**Docket UE-210795**

**SIXTH EXHIBIT TO THE PREFILED RESPONSE TESTIMONY OF  
ELAINE K. HART  
ON BEHALF OF NW ENERGY COALITION AND FRONT AND CENTERED**

# Puget Sound Energy ELCC Workshop

Energy & Environmental Economics ELCC Review

# January 2027 Dispatch Plots: Week of 1/25

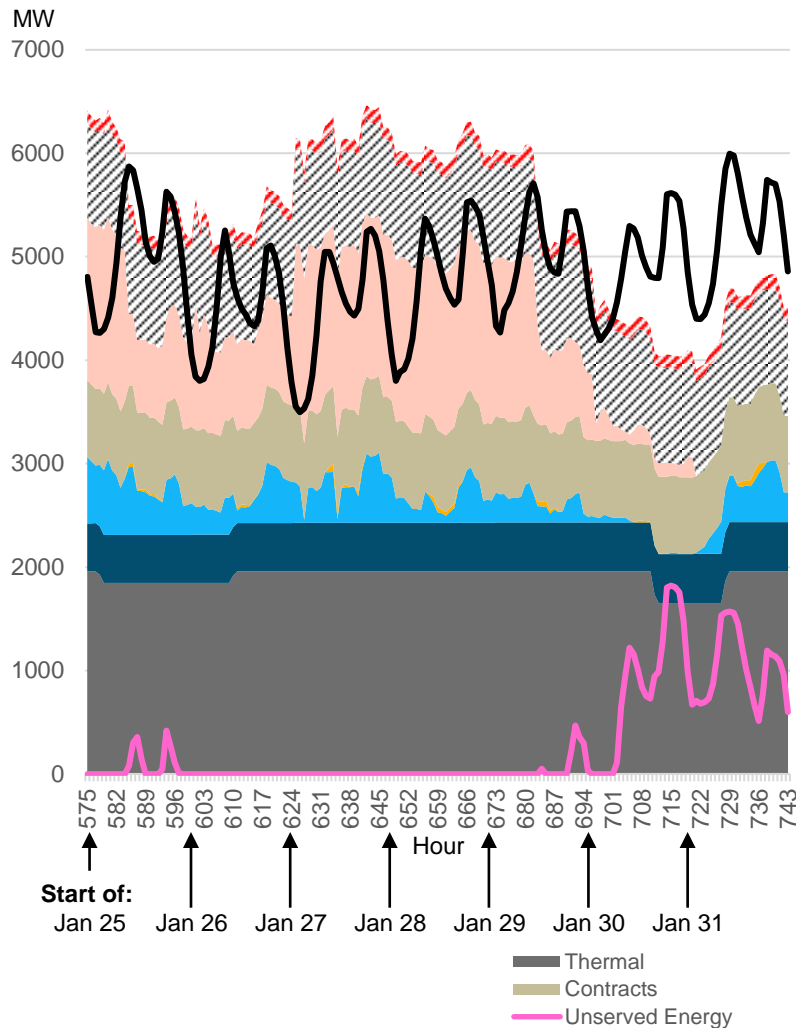
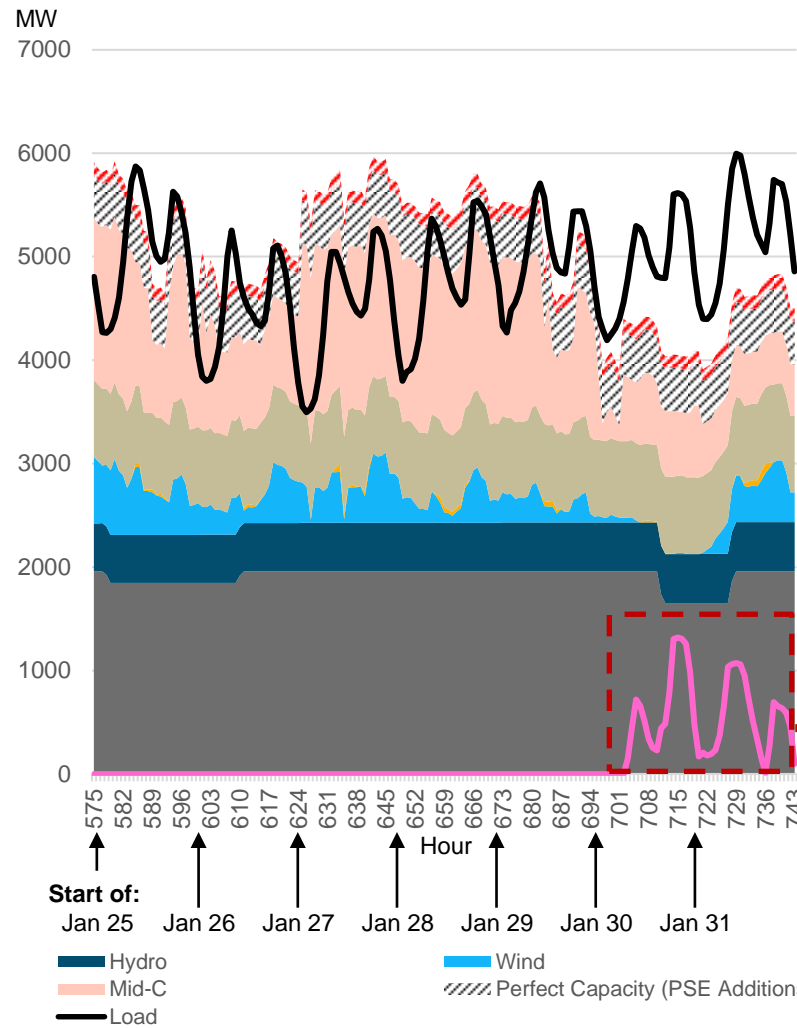
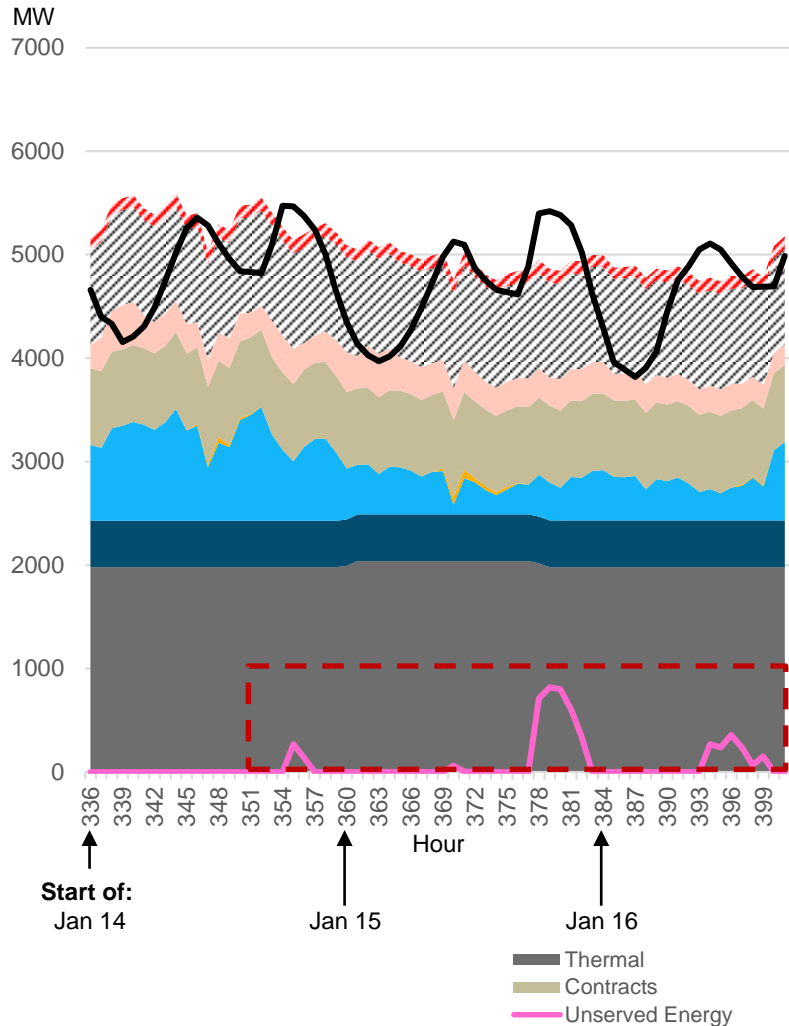
- + To estimate the impact of modifying Mid-C output, E3 focused on the week of January 25**
  - The week of January 25 is the focus because of a 42-hour outage that occurs during this week in draw 1687

- E3 modified the PSE Base Case so that 500 MW of additional capacity is available from Mid-C during unserved energy events, reflecting PSE's share of illustrative regional capacity additions. In tandem, E3 reduced the perfect capacity additions assumed on the PSE system by 500 MW

- + Modifying the PSE Base Case so Mid-C output is increased by 500 MW during unserved energy events does not reduce the duration of the 42-hour outage, illustrating the impact of Mid-C on the outage characteristics against which battery storage is tested**

- + Outage duration (continuous) = 42 hours
- + Maximum unserved energy = 1,821 MW
- + Minimum unserved energy = 110 MW (hour 702)
- + Mid-C output during outage = 61 MW (avg)

- + Outage duration (continuous) = 41 hours
- + Maximum unserved energy = 1,321 MW
- + Minimum unserved energy = 13 MW (hour 736)
- + Mid-C output during outage = 561 MW (avg)

# January 2027 Dispatch Plots: January 14-16

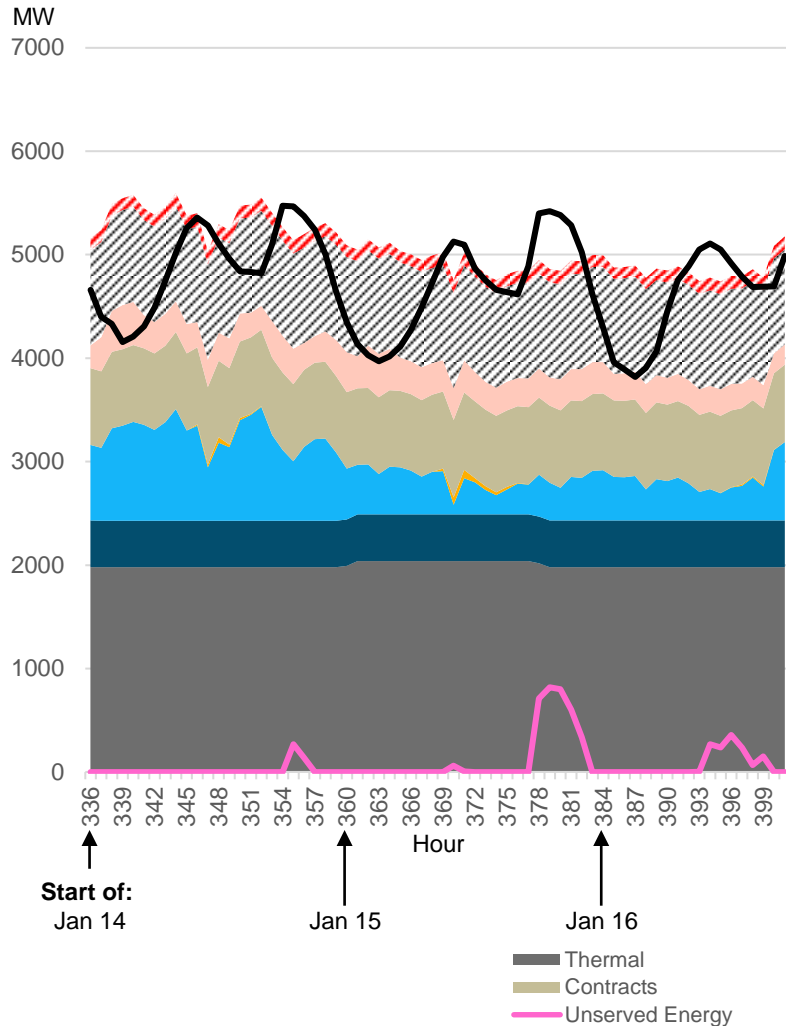
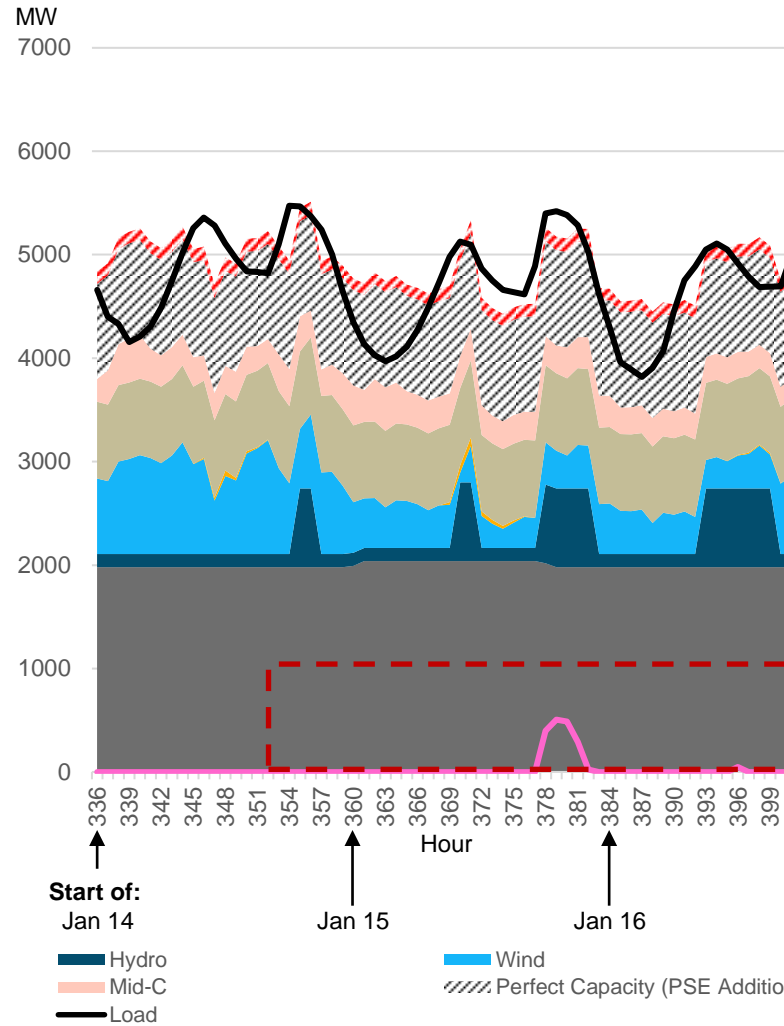
- + To estimate the impact of modifying PSE's hydro modeling, E3 focused on January 14 – 16**
  - This period contains multiple shorter-duration outages that illustrate the impact of flexible hydro dispatch

- PSE Base Case hydropower resources are modified to operate with energy limitations (50% capacity factor, pmin of 25%) and dispatch capabilities (i.e. output can be increased to pmax when there is unserved energy)

- + Modifying hydro resources so they are energy-limited and dispatchable illustrates the ability of hydro to meet unserved energy needs over shorter-duration periods (e.g. 4-6 hours)**

- + Outage duration (longest) = 7 hours
- + Maximum unserved energy = 818 MW
- + Minimum unserved energy = 2 MW (hour 393)

- + Outage duration (longest) = 5 hours
- + Maximum unserved energy = 507 MW
- + Minimum unserved energy = 25 MW (hour 382)
